DEVELOPMENT HEARING OFFICER
SUPPLEMENTAL SUBMITTAL

PROJECT NO. PR-2022-00710

Application No. SD-2023-00038

**RE: RESPONSE TO DHO COMMENTS MARCH 8TH, 2023
FOR PROPOSED REPLAT TRACT MM-1-B-1 AND TRACT MM-1-B-2 SEVEN BAR RANCH
PR-2022-007100
SD-2023-00038**

FIIZ DRINKS ALBUQUERQUE, NM	DRAWN BY JL
	SIDEWALK EXHIBIT	DATE 3-17-2023
		DRAWING
		SHEET # SW-1
AMANDA HERRERA P.E. #23575	 TIERRA WEST, LLC 5571 MIDWAY PARK PL NE ALBUQUERQUE, NEW MEXICO 87109 (505) 858-3100 www.tierrawestllc.com	JOB # 2022048

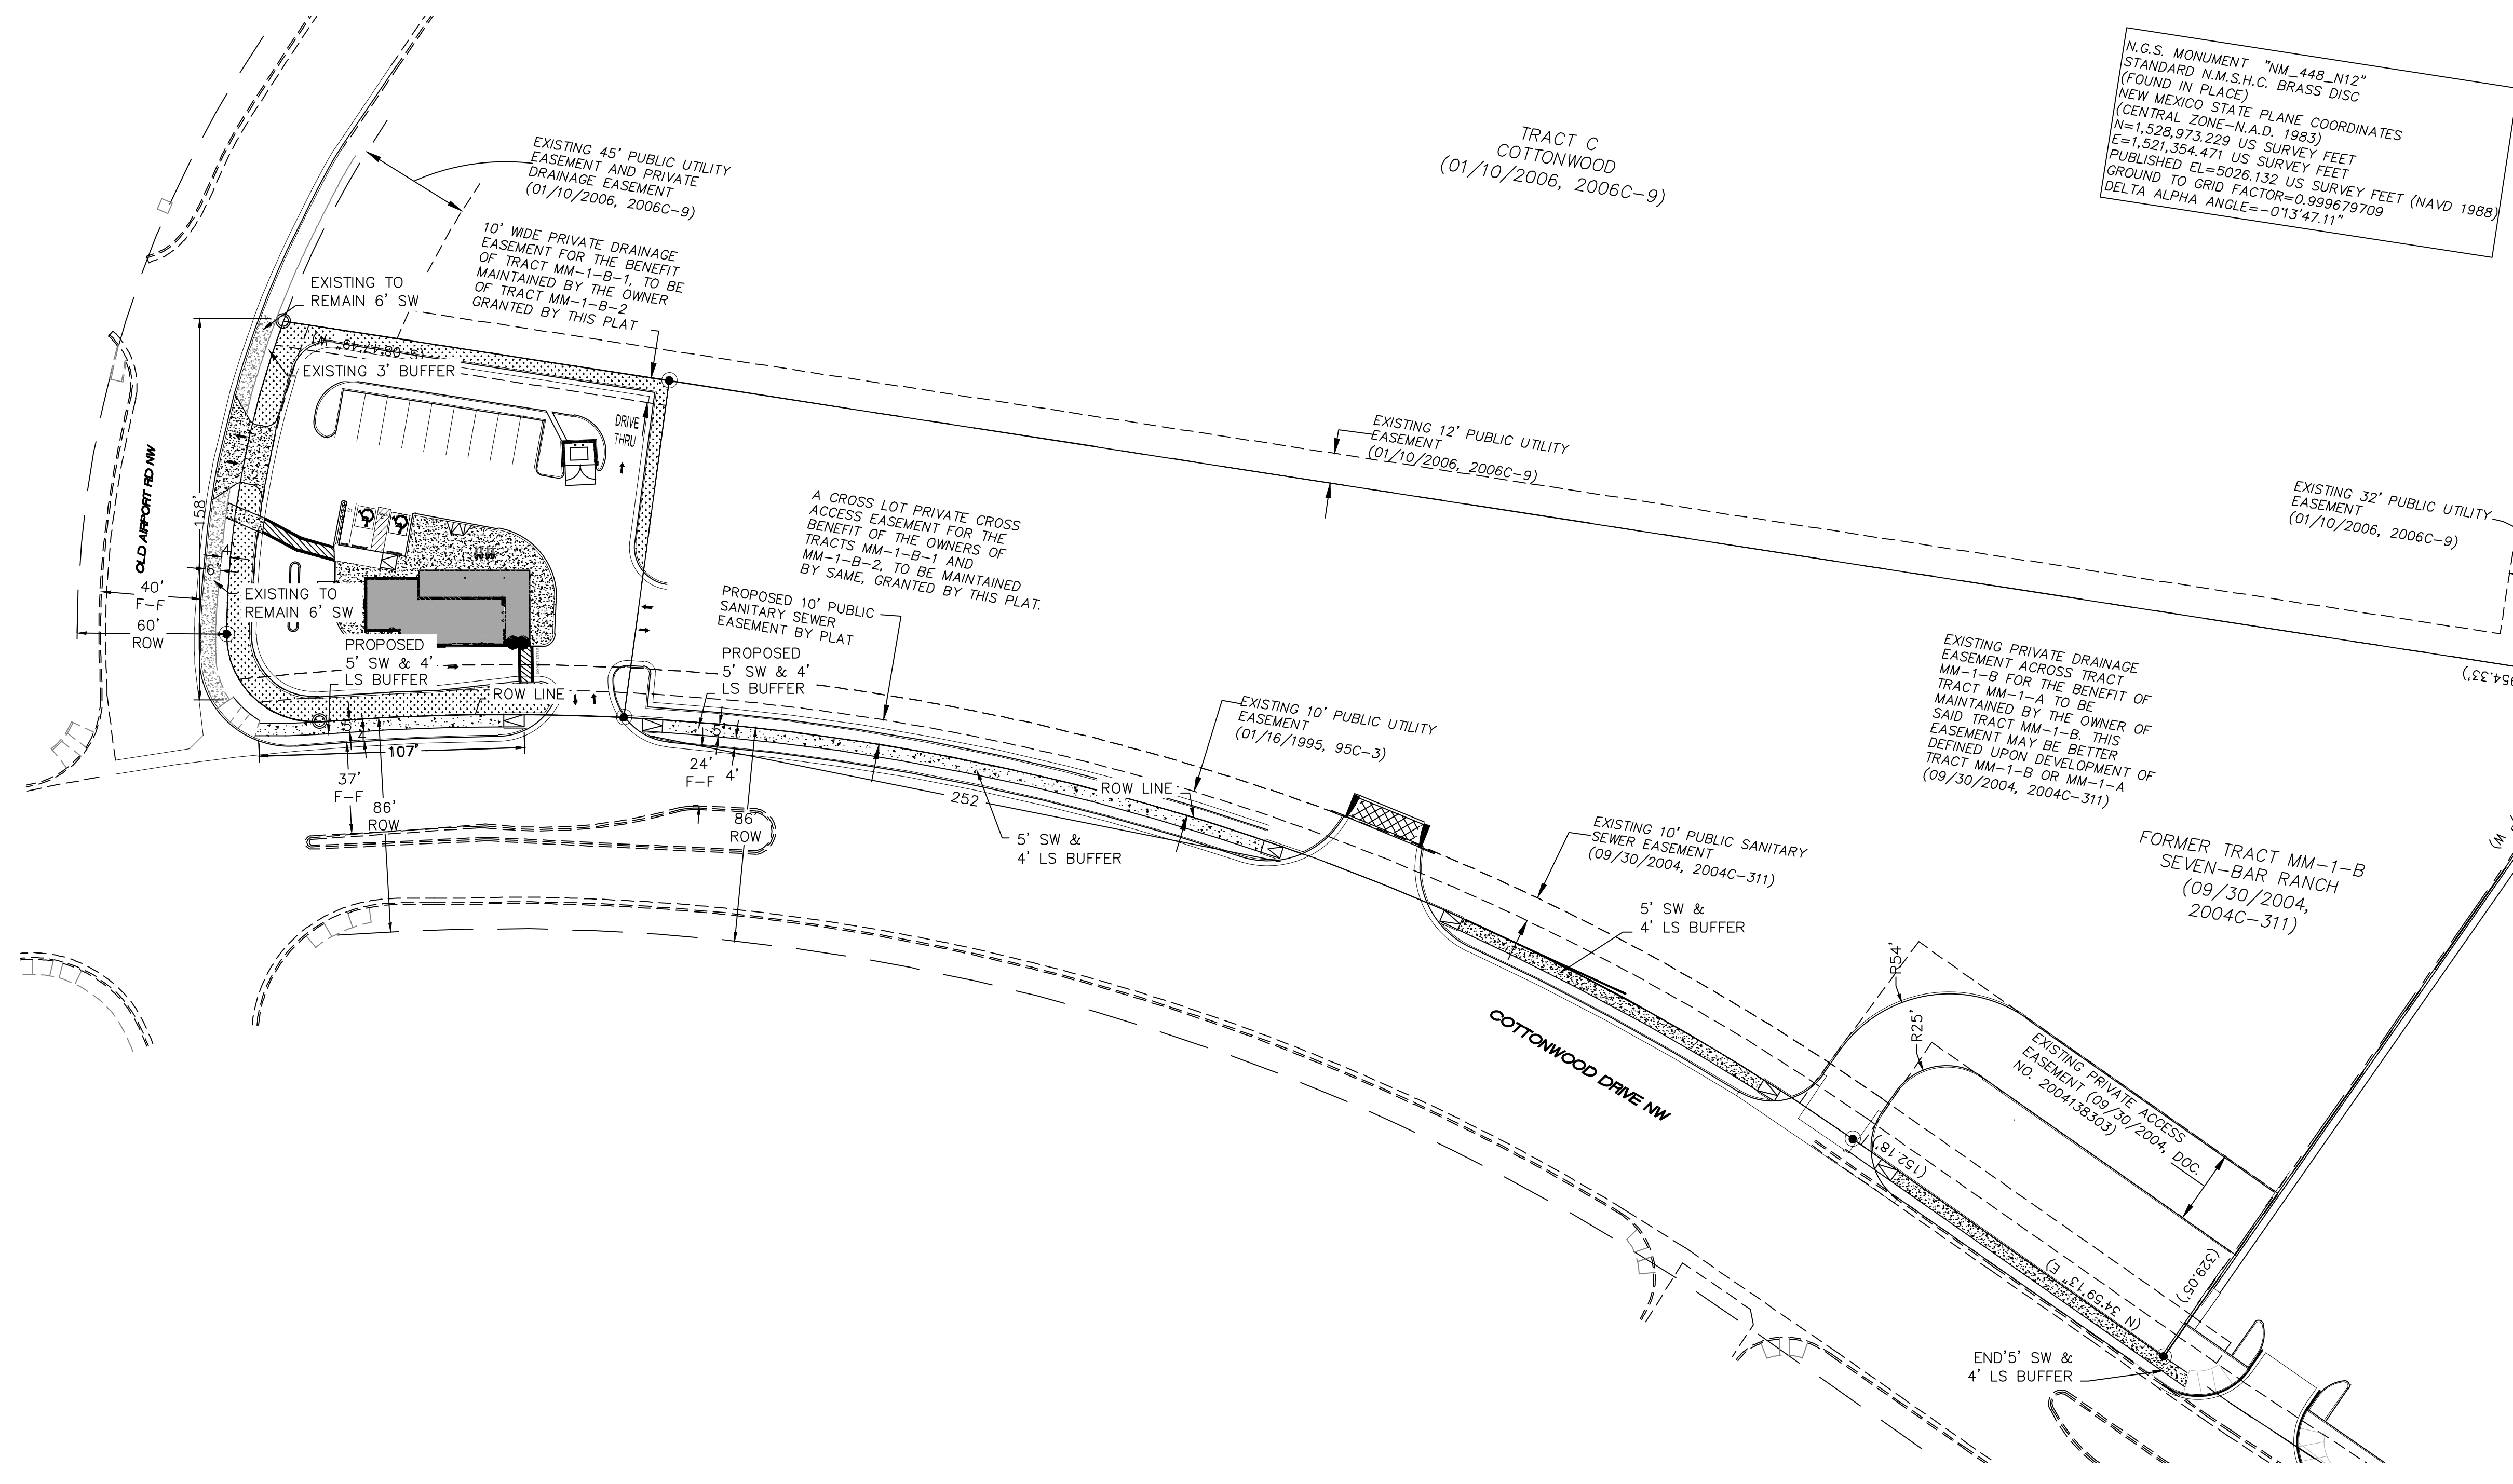
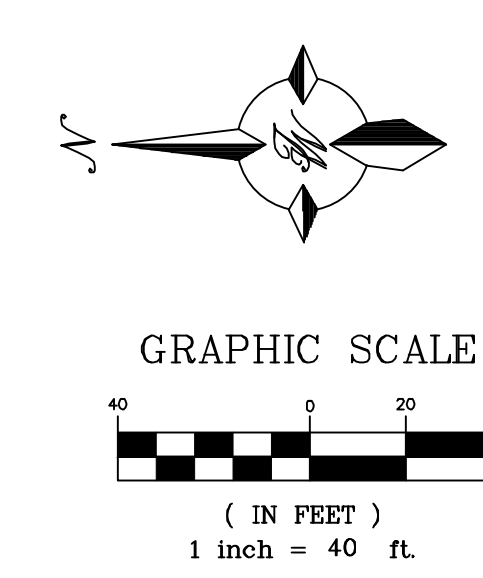
1. This project is within a Center and a Major Transit Corridor. Airport Drive and Cottonwood Drive are local roads. Proposed 6' sidewalk is acceptable, but a 5-6' landscape buffer is also required between the sidewalk and curb per the DPM. This was requested at sketch plat but I do not see this addressed. Right of way may be required.

6. Compliance with section 7 of the DPM is required per Table 7.2.29. Sidewalk width is 6 feet and a landscape buffer between the curb and the sidewalk should be 5-6 feet. Sidewalk is existing on Old Airport Road. Sidewalk needs to be built along Cottonwood Drive.

RESPONSE: Due to our limited spacing for the required 20-ft dedication on the SAS line extension, we're proposing a the 4-ft buffer with the 1-ft encroachment into the sidewalk with tree grates. This can still maintain the walkway width requirements as well as provide the spacing for trees to assist with pedestrian safety along Cottonwood Dr. The exhibit can be found below for DHO's review and approval. We're hoping this will meet DHO's approval due to the limited spacing and already dedicating a large portion of the site to Utility and Sewer Easements. See Exhibit below.

RESPONSE: Due to our limited spacing for the required 20-ft dedication on the SAS line extension, we're proposing a the 4-ft buffer with the 1-ft encroachment into the sidewalk with tree grates. This can still maintain the walkway width requirements as well as provide the spacing for trees to assist with pedestrian safety along Cottonwood Dr. The exhibit can be found below for DHO's review. Correspondence has been also provided with Planning. We're hoping this will meet DHO's approval due to the limited spacing and already dedicating a large portion of the site to Utility and Sewer Easements. See Exhibit below.
